REMEDIATION SYSTEM EVALUATION

CLEBURN STREET WELL SUPERFUND SITE GRAND ISLAND, NEBRASKA

Report of the Remediation System Evaluation,
Site Visit Conducted at the Cleburn Street Well Site
April 24, 2001

**Final Report Submitted to Region 7
July 30, 2001**

FIGURE 1-1. SITE LAYOUT SHOWING THE CONTAMINANT SOURCES, GROUNDWATER EXTRACTION WELLS, SVE WELLS, AND THE 1999 PCE PLUME.

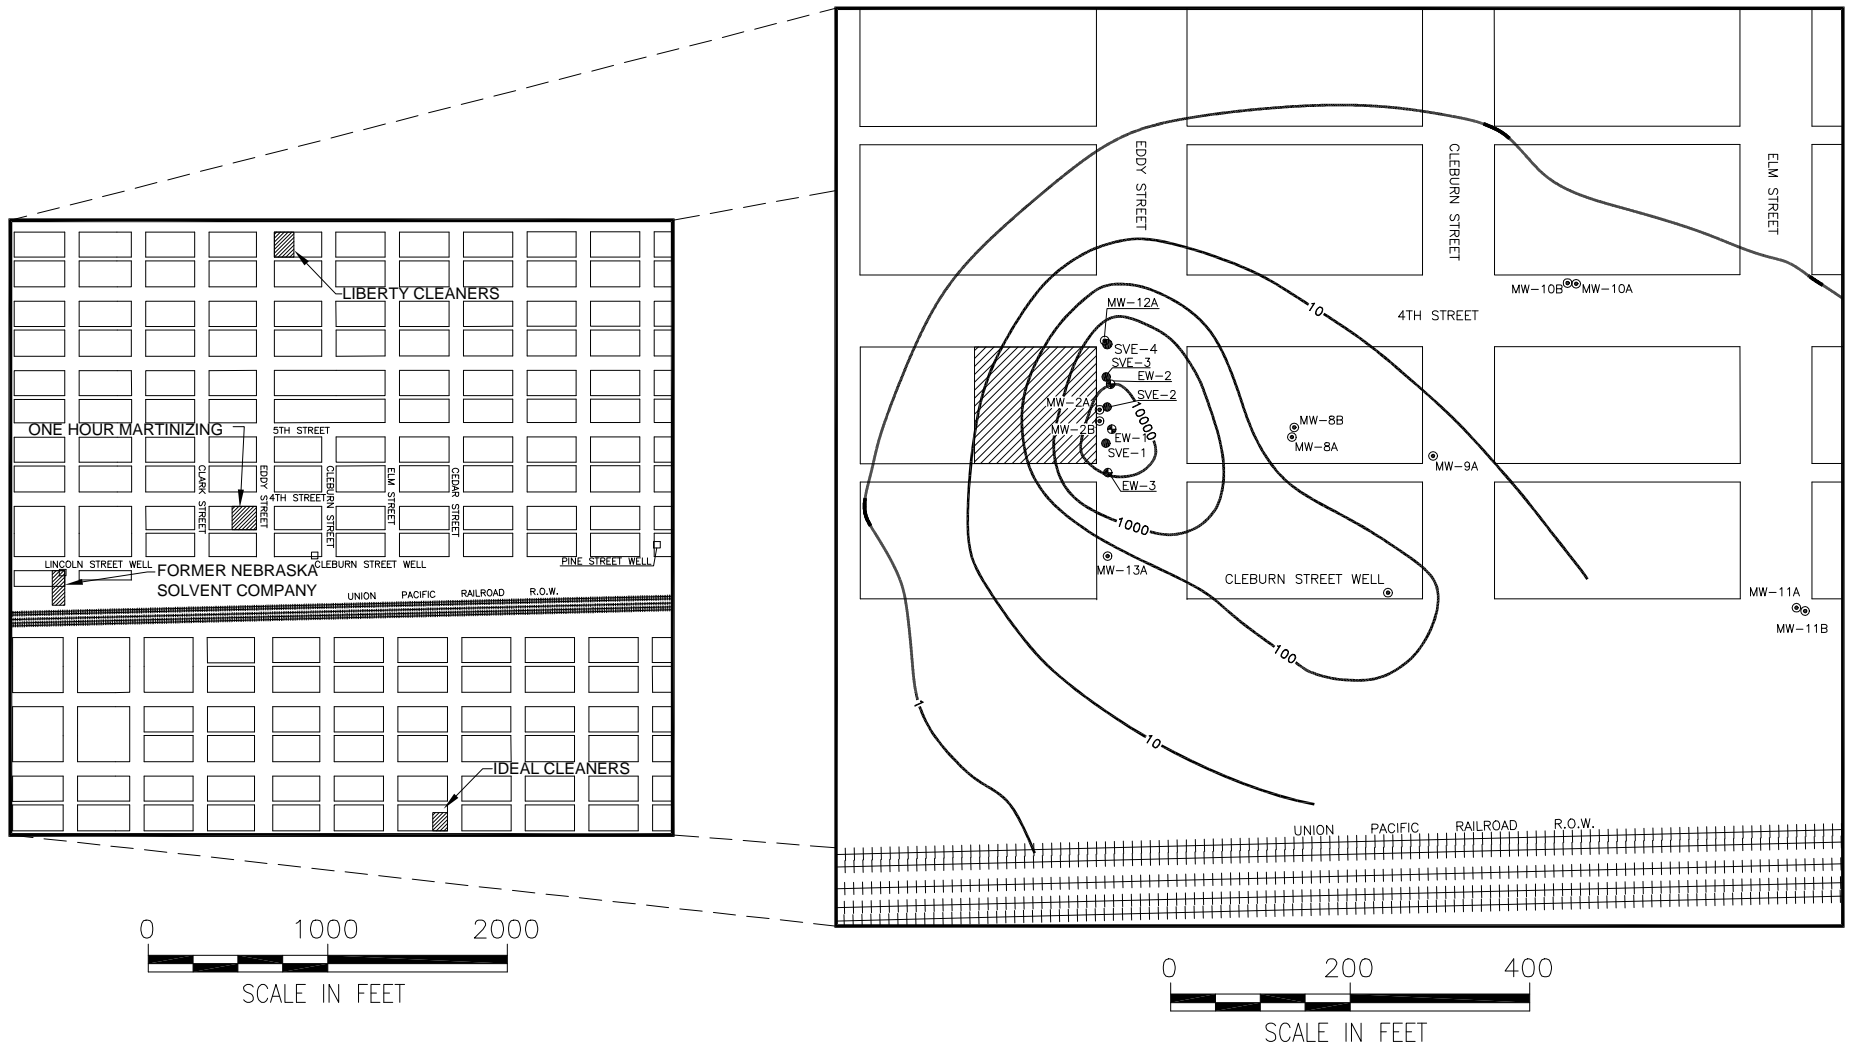
The site layout with the identified contaminant sources and contaminant plume is depicted in Figure 1-1.
